Products: 700006 - 1/2" Snap ring
Serial Range: SRG-400 - G4000149 to Present
Release Date: February 2018

Snap Ring for SRG Convection Fan Motor

Ring Location on Motor

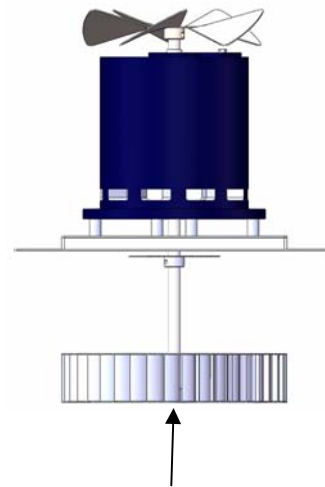
A 1/2" snap ring is used at the end of the convection fan motor shaft to prevent the blower wheel from dropping off of the shaft in the event the blower wheel's set screws become loose. The snap ring is located on the shaft by a groove in the circumference of the shaft. The snap ring will now ship with the convection fan motor when a replacement motor is purchased. The snap ring will be taped to the housing of the motor and should be installed with a pair of snap ring pliers.
